AMENDMENTS TO THE DRAWINGS

REMARKS

FIG 3

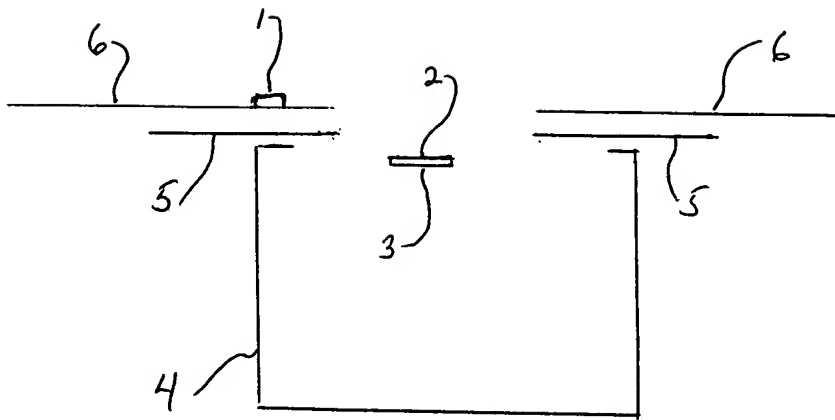
The Examiner objected to the drawings as not showing every feature of the claimed invention. The Examiner states that the two-sided display, same information displayed must be shown. Applicants submit that the Examiner's statement is incorrect in that the two-sided display has different information displayed on opposite sides. However, Applicants are submitting new

Submitted herewith is an annotated sheet showing new Figure 3. New Figure 3 more clearly shows the two-sided display having different information displayed on opposite sides.

Fig. 3 which shows this arrangement more clearly. This figure shows the elevator car 4 when viewed from the top with the two-sided display mounted in front of the elevator door so that display 2 can be observed from the lobby while display 3 can be observed from inside the elevator. Also, display 1 is shown as being mounted on the lobby wall. This arrangement is also shown in Fig. 2. However, Fig. 3 has been submitted to show this more clearly from a different angle. Accordingly, this drawing objection is believed to be overcome.
